MAY 2017 STAGE 1 SSDA

SYDNEY METRO MARTIN PLACE STATION MACQUARIE'S UNSOLICITED PROPOSAL

Test fitout, typical high-rise floorplate

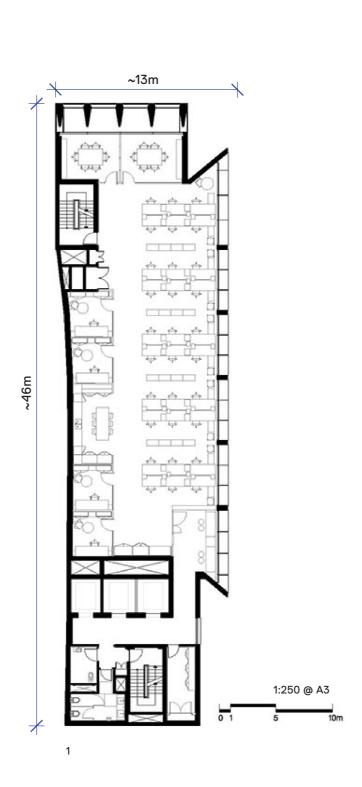
"Demonstrate that the southern tower is capable of delivering a workable / functional commercial floorplate, which will be attractive to prospective tenants and provides a high level of internal amenity for employees, without relying on the outcome of the Planning Proposal."

This plan shows an example of an indicative furniture layout, and demonstrates the viability of the floorplate for a tower with a 25m setback.

Plan showing the highly permeable ground planes of both the North and South Sites

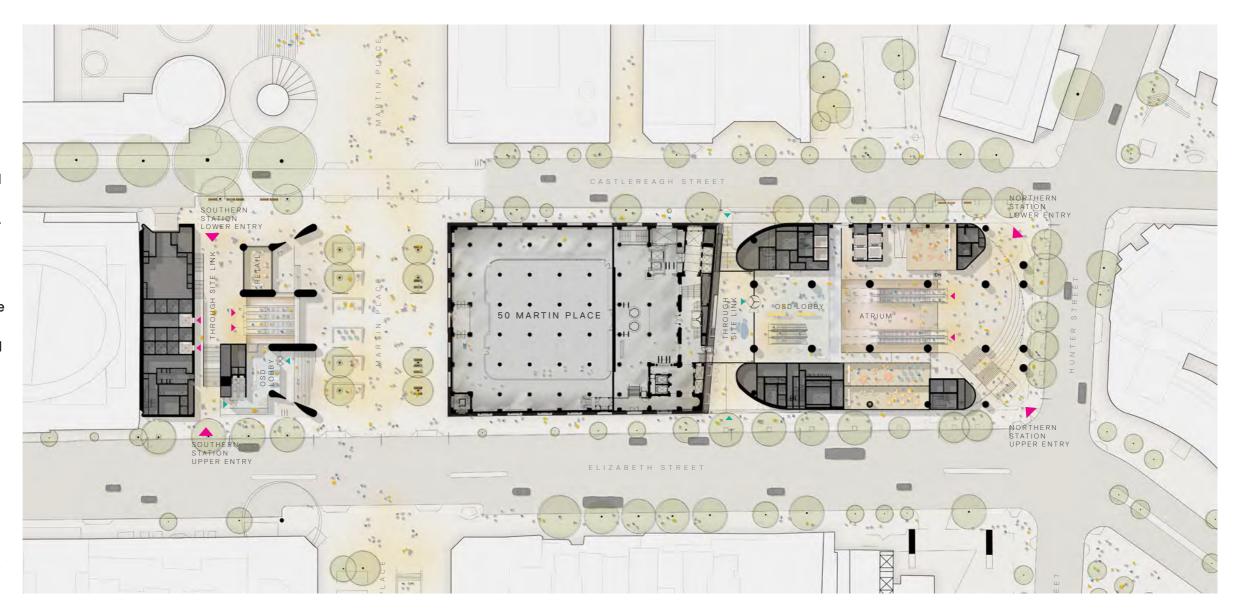
"Provide further design justification for the proposed colonnade on the south building, having regard to City of Sydney Council's concerns. This must balance the operational needs of the station entry with the predominant street wall facade with zero setback on Martin Place."

The developed South Tower scheme has removed the colonnade.

The design of the podium to 39 Martin Place is required to resolve the practical need for visibility of the Metro station, for activation of the public domain and for a solid, masonry experience that is contextually related to the heritage facade of 50 Martin Place.

The proposed design has resolved this by providing a base that appears either solid or transparent according to viewing points, enabling a solid appearance in keeping with 50 Martin Place, and local visibility to the transport, retail and commercial functions.

- 1 Precedent images of link spaces: Rotermann's Old and New Flour Storage and Kings Cross Station
- 2 3D impression of through site link "interlude" between 50 Martin Place and North tower.

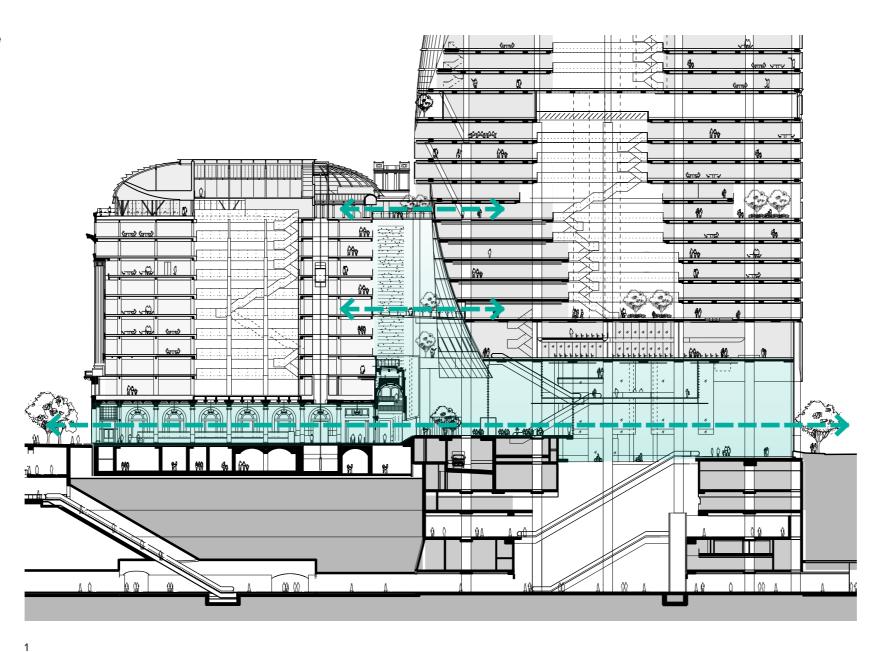
"Provide details showing how the north tower building envelope will physically connect into 50 Martin Place. This should include indicative plans and/or illustrations showing the existing and proposed connections, and an assessment of these connections on the heritage significance of 50 Martin Place."

A through site link "interlude" between the two buildings is a central part of the scheme that has been developed to create activity and energy at ground level and up throughout the podium floors. Discreet bridge links are proposed to connect through this space into 50 Martin Place at key "active" floors - the Ground Floor Banking Chamber, Level 5 Office Plaza and the Level 10 Client Terrace Level.

The three connections
proposed between 50 Martin
Place and the building on the
North Site are located within
areas identified as having
exceptional heritage significance
– the Grand Hall and Level 10
– and high significance – the
northern lightwell at Level 5.
